Sandy Plains Senior Living Cobb County, Georgia Z-106

Conceptual
 Site
 Plan
 Scheme G

PETITION NO: Z-106

PLANNING COMMENTS:

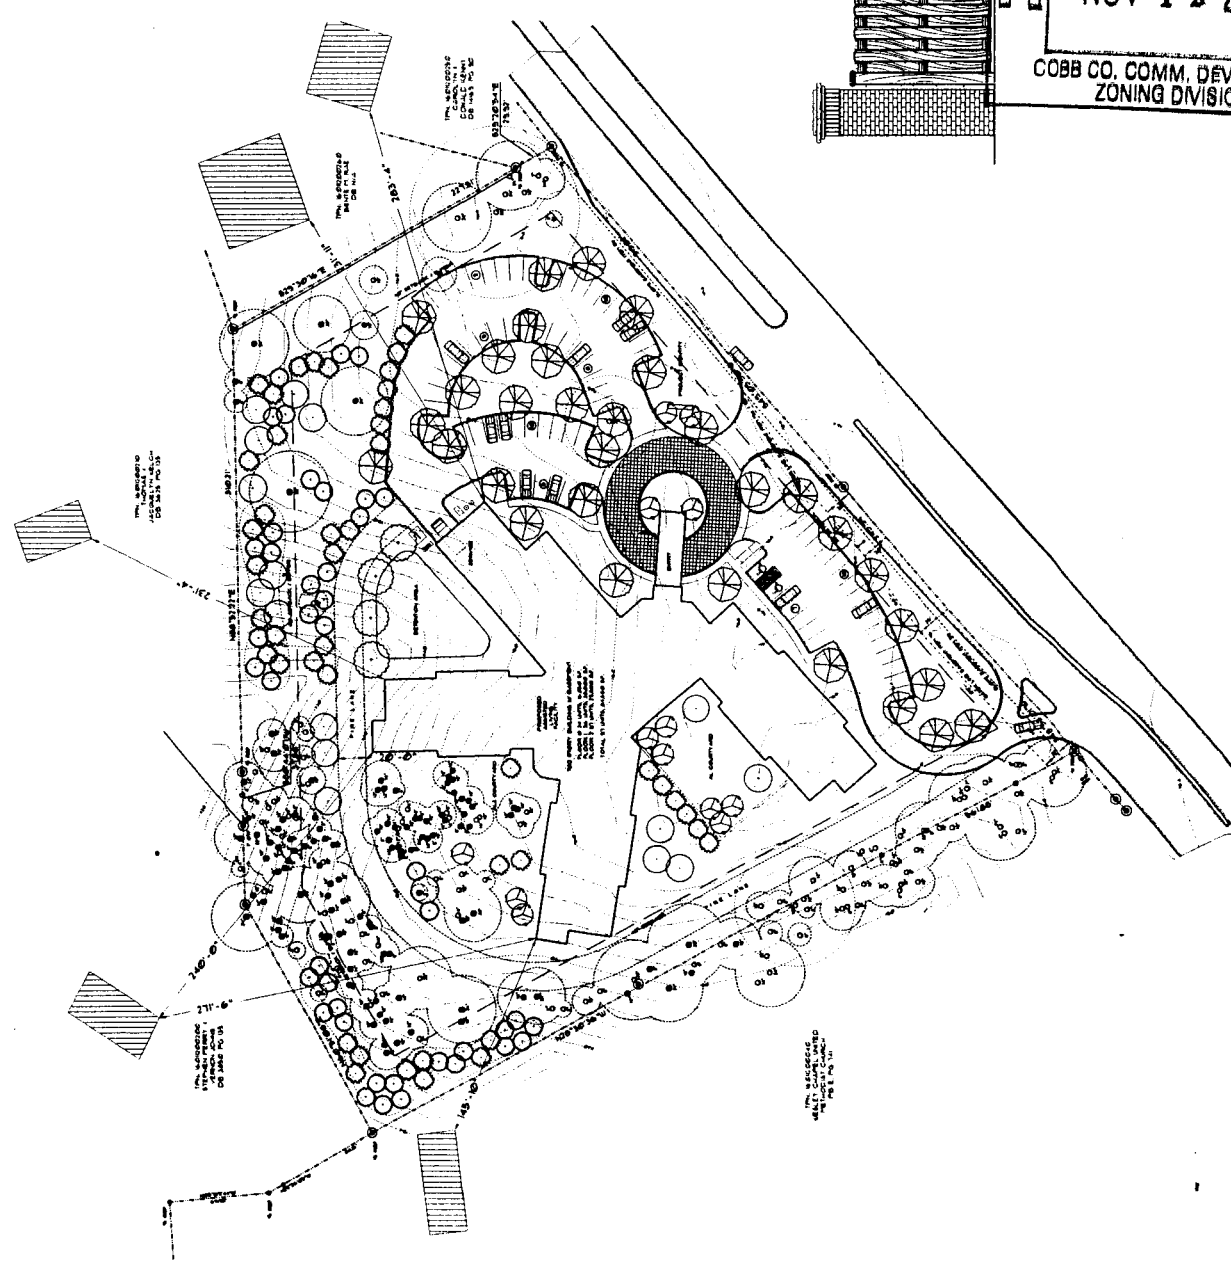
1. The existing site is developed as two estate-sized residential lots. The majority of the site drains to the north through a pair of existing residential lots within Jefferson Township S/D. Slopes on the site range from relatively flat along the Sandy Plains Road frontage to approximately 28% within a ravine located at the rear of the property. The average slopes on the site are less than 15%. The majority of the site is well-wooded with the front third fairly open.

2. The extensive existing tree stand and undergrowth provide significant air/water quality, soil stabilization and storm flow mitigation benefits for this watershed. Construction of this project will eliminate the vast majority of this vegetation and increase impervious area, storm runoff and non-point source pollution. To compensate, the First Flush Water Quality Best Management Practice Requirements must be elevated to the 1.5-inch rainfall event and each larger storm discharge controlled not to exceed the allowable discharge of the next lower, more frequent storm event (ie. 5-year storm event released at 2-year rate; 10-year event at 5-year rate; etc. to 100-year event at 50-year rate).

3. As indicated in the Downstream Conditions Comments, there is a downstream private pond located at 4479 and 4482 Park Place Terrace that will require a pre- and post-development sediment survey.

4. The proposed detention pond discharge is a fairly well defined conveyance. However, the subdivision plat for Jefferson Township Phase 10 does not show a recorded drainage easement for this flow path. This issue must be resolved in Plan Review
